# Access Compliance Report

## Public Rights-of-Way

| Intersection ID: 7195                   | Main Street: REAGAN_DR | Cross Street: TOM_HUNTER_RD             | Location: SE           |
| ADA ID: 6A0E0DD3EC38                    | Ramp Type: Para        | Initial Pass/Fail: Fail                 | Overall Compliance: No |

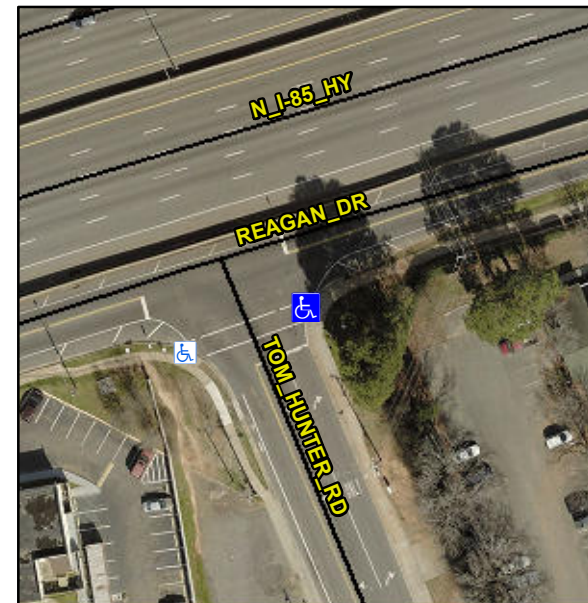
**R304.3.2, R304.5.3**

| Compliance | Description          | Data  | Compliance | Description                 | Data |
|------------|----------------------|-------|------------|-----------------------------|------|
| Yes        | Ramp Slope LT (%)    | 5.4   | No         | Ramp Slope RT (%)           | 18.2 |
| Yes        | Ramp XSlope LT (%)   | 1.4   | No         | Ramp XSlope RT (%)          | 3.8  |

**Remove & Replace Entire Ramp.**
